148. PLCA Reconciliation Sublayer (RS)

Commented [PB1]: #589: PLCA definition

Figure 148–3—PLCA functions within the generic Reconciliation Sublayer (gRS)

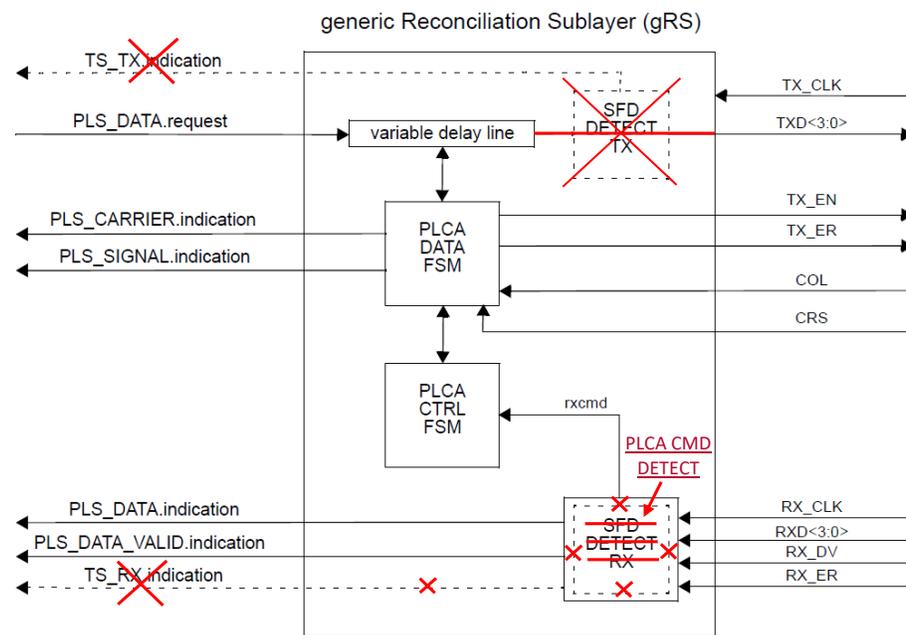
Commented [PB7]: #715, #716: remove TSSI support
NOTE: in figure, remove all dashed lines

Commented [PB8]: #716: remove TSSI support

Figure 148-4—PLCA Control state diagram (1 of 2)

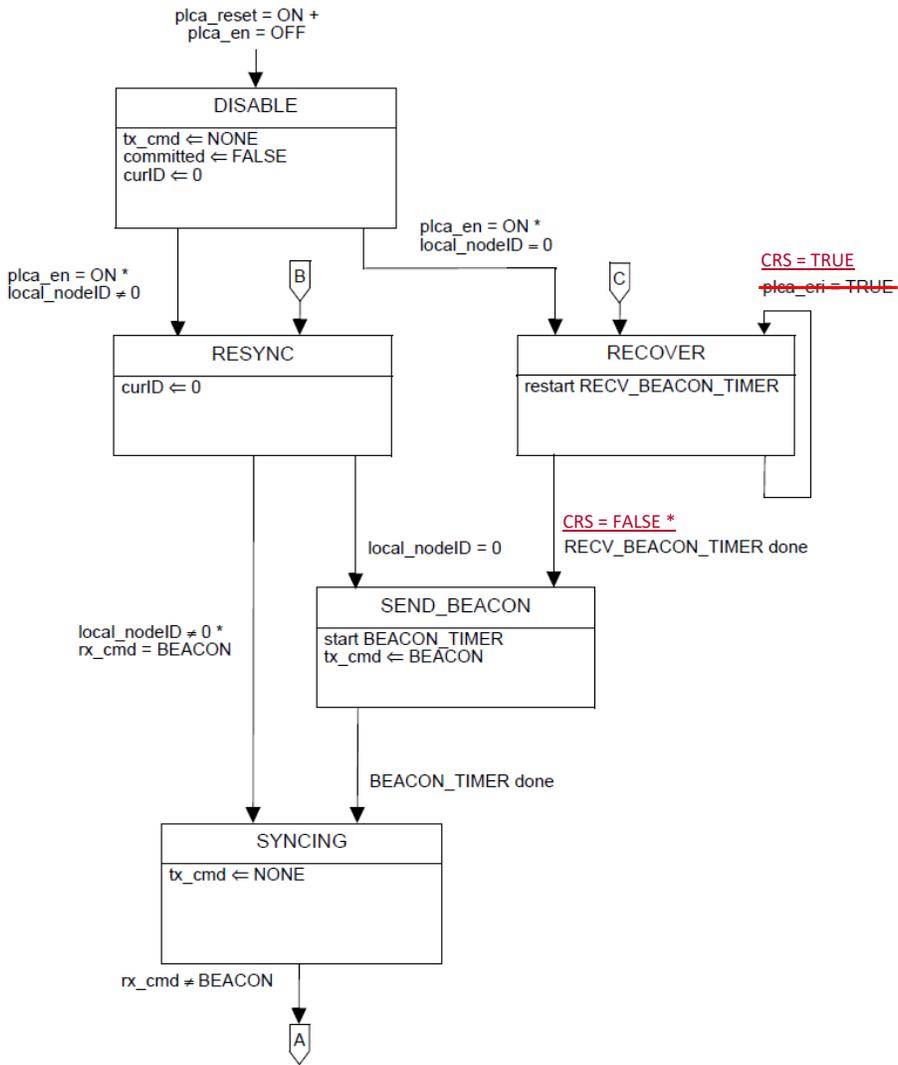
Commented [PB20]: #649, #287: CRS usage
replace `plca_eri` with `CRS` since now they are functionally equivalent

Commented [PB21]: #520: ambiguous exit condition
Added "`CRS = FALSE *`" to transition from **RECOVER** to **SEND_BEACON** state

Figure 148-5—PLCA Control state diagram (2 of 2)

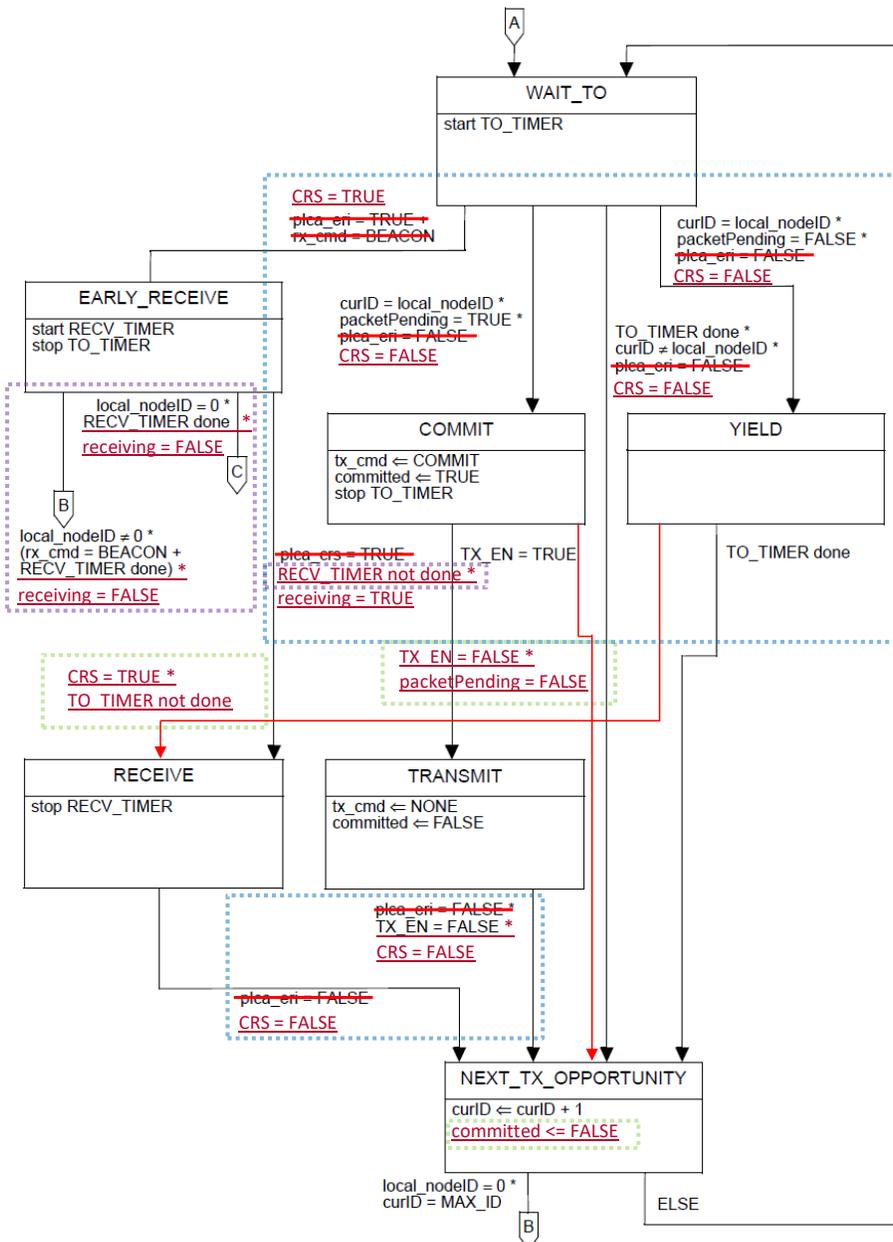
Commented [PB22]: #649, #287: CRS usage replace plca_eri with CRS since now they are functionally equivalent.

In transition from EARLY_RECEIVE to RECEIVE, use combination of "RX_DV asserted" OR "COMMIT received" to detect whether the signal being received is a valid packet or a COMMIT indication (which is always a precursor to a valid packet)

Changes highlighted in BLUE boxes

Commented [PB23]: #558, #557: Resolve ambiguous exit conditions

Changes highlighted in PURPLE boxes

Commented [PB24]: #551, #550: PLCA_XWORK Implement changes to have PLCA enabled nodes interoperate as expected with non PLCA-enabled nodes.

Changes highlighted in GREEN boxes

NOTE for editors: suggested to move YIELD state box to the left to avoid crossings

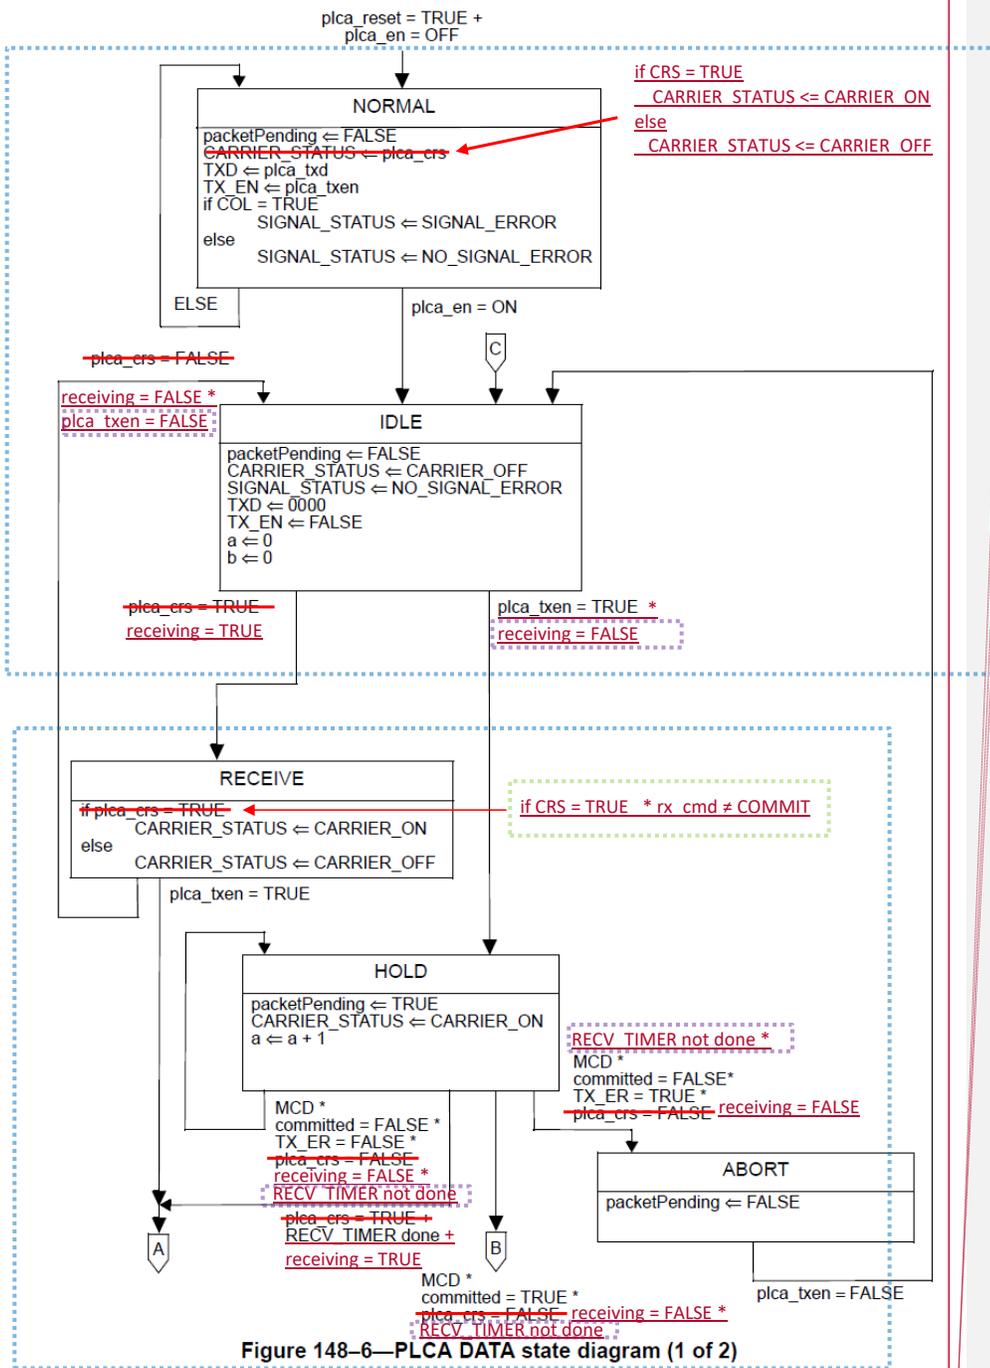
Commented [PB29]: #649, #287: CRS usage replace plca_eri with CRS since now they are functionally equivalent.
 Changes highlighted in BLUE boxes

Commented [PB30]: #613: Bandwidth inequality Don't signal carrierSense to MAC during a COMMIT
 Changes highlighted in GREEN boxes

Commented [PB31]: #523, #522, #521: Ambiguous exit conditions
 Changes highlighted in PURPLE boxes

Figure 148-7—PLCA DATA state diagram (2 of 2)

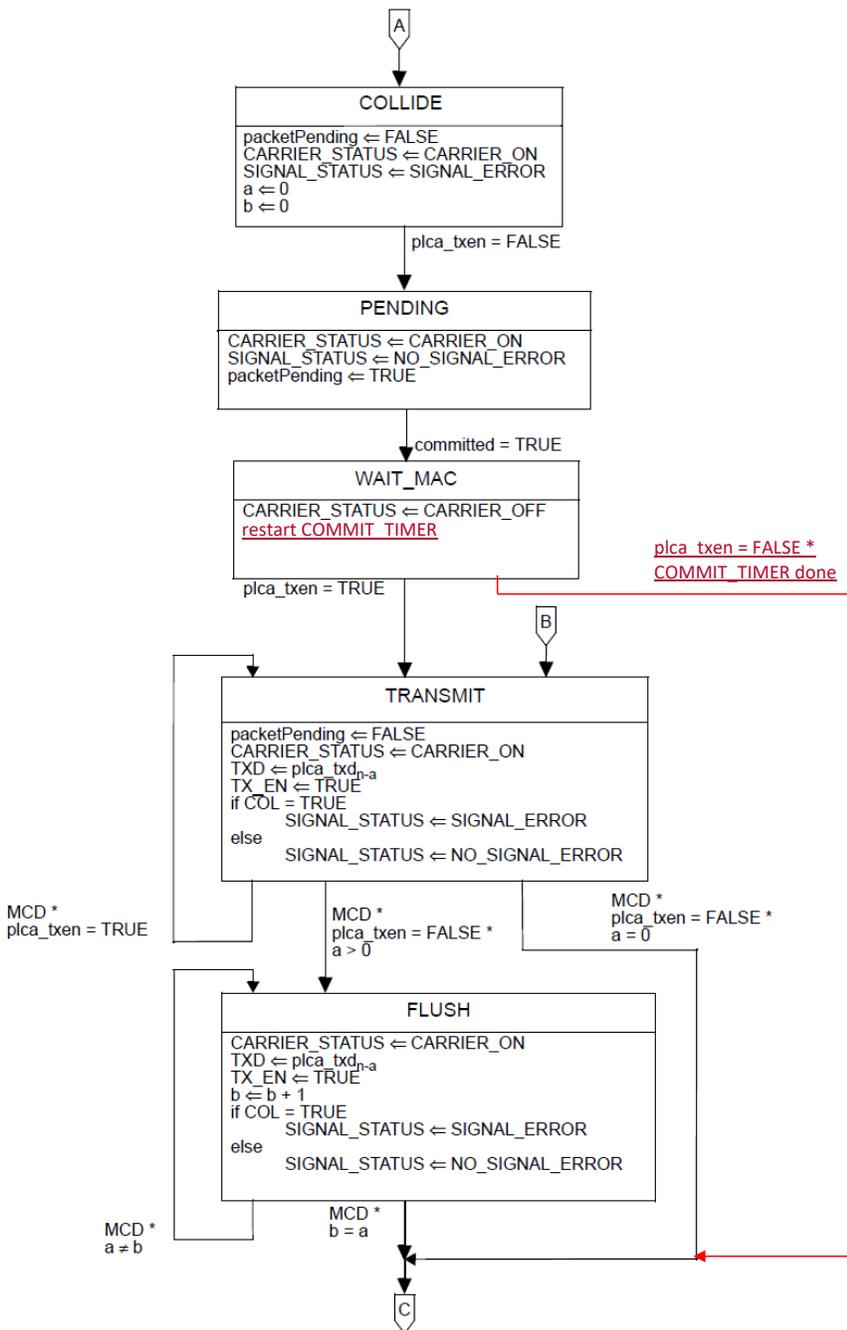
Commented [PB32]: #552: PLCA_XWORK
 Implement changes to have PLCA enabled nodes
 interoperate as expected with non PLCA-enabled nodes.
